**ADDENDUM NUMBER 2**  
**DATED AUGUST 7, 2020**  
**TO**  
**SPECIFICATIONS TO REQUEST FOR BIDS #21004**  
**FOR**  
**AVR SHOWROOM EQUIPMENT**

FLOOR PLAN

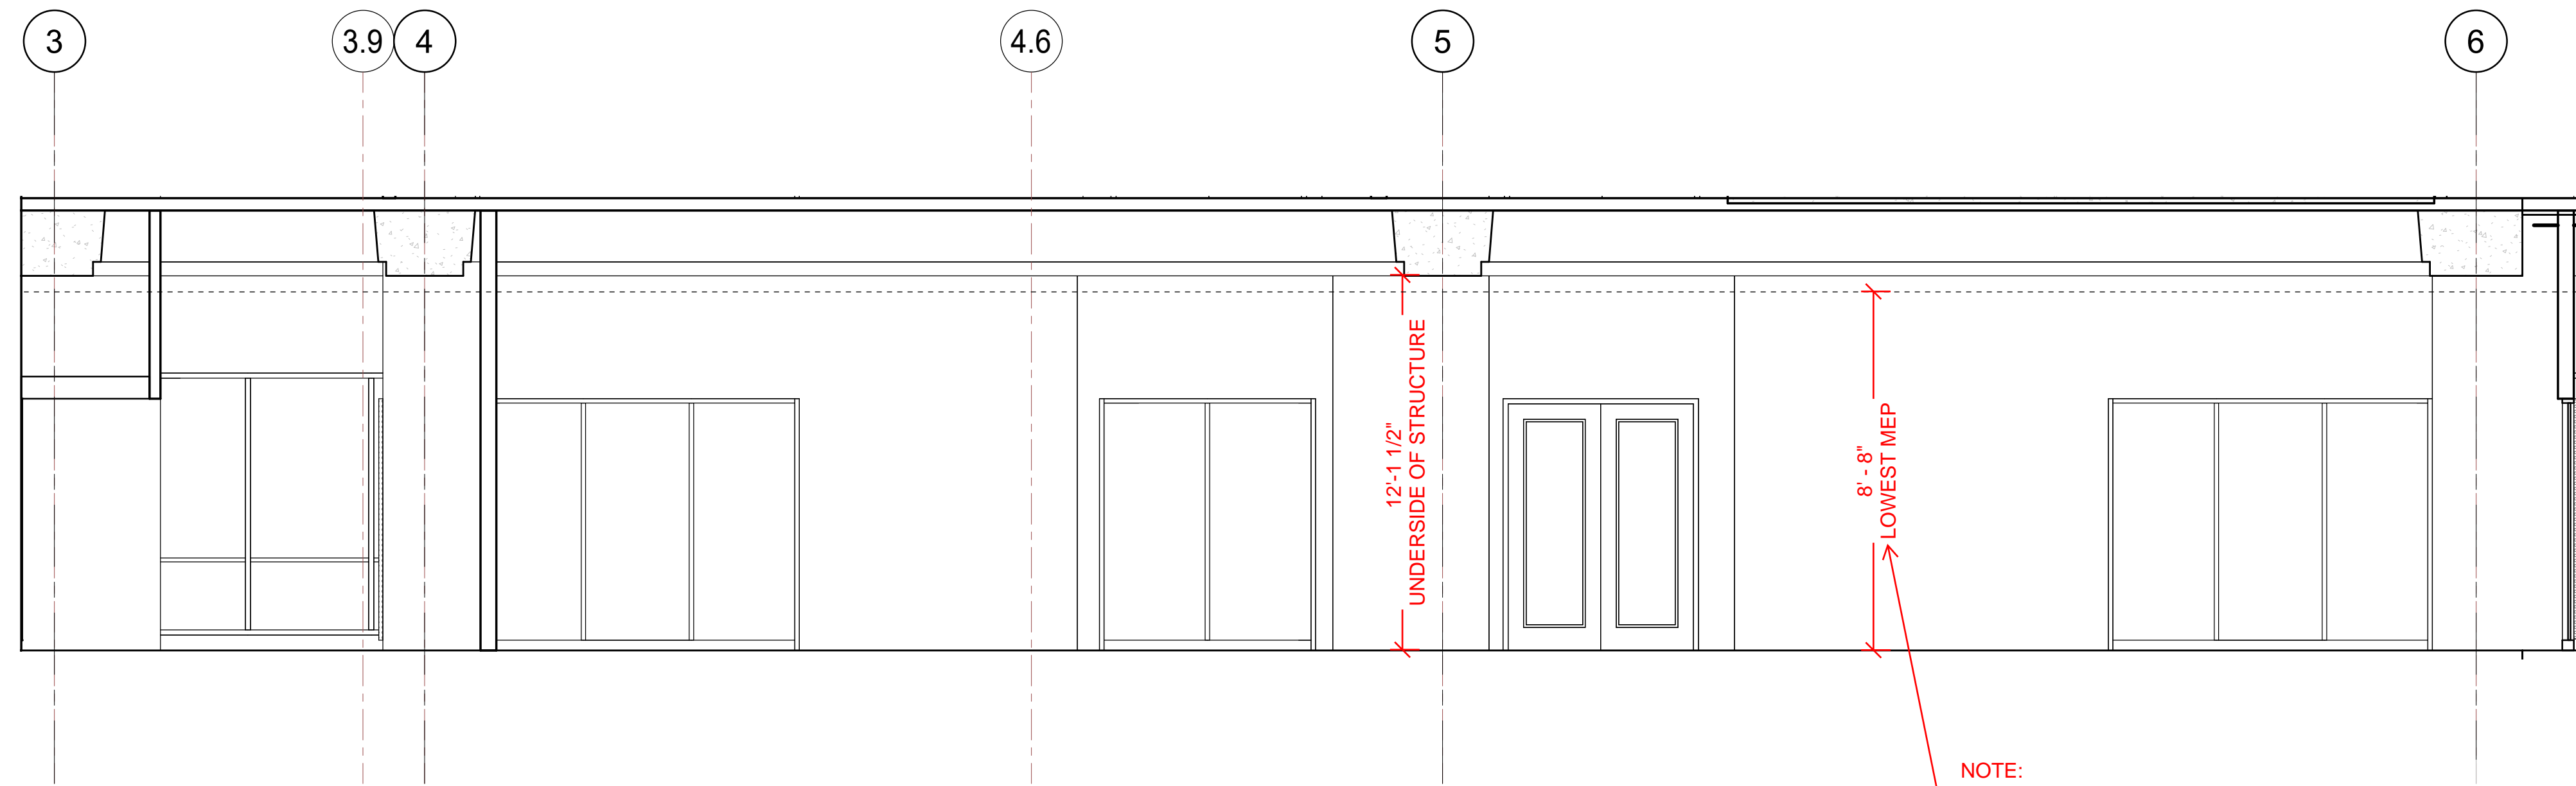
4. **Question:** Item 1: Please provide any relevant architectural drawings, details, or images of the subject space. The physical constraints presented by the installation location have a significant effect on the design approach and overall cost.

**Answer:** Attached
5. **Question:** Item 1: The specified screen size is 25'x8'. Our engineering team assumes that this is referring to width and height of the desired display area. Do you have a specific target curvature radius for the display as well?

**Answer:** Estimated screen size would be 8.5m x 2.7m. It is recommended that suppliers include specifics regarding the proposed equipment. Screen size and screen FOV/curvature, depending on screen size, will optimize VR immersive experience with viewing/seating arrangement and space constraints shown on the architectural diagram
